CHANGES FROM BASE PRODUCT BE-L130 (#0800) TO BE-L130(AH) (4416)

Status		Released		Assembly Ref	
RELEASED		BE-L130(AH)			
Part No		BE-002453-03-13

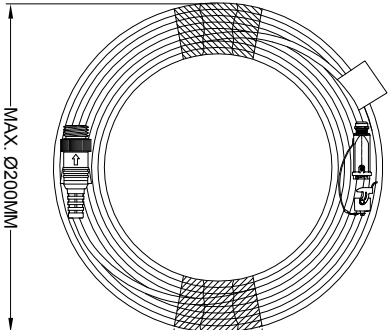
CHANGE: 1. MALE 4 PIN DIN CONNECTOR REMOVED

2. HARTING 8 PIN MALE CONNECTOR AND LAPP CABLE GLAND ADDED
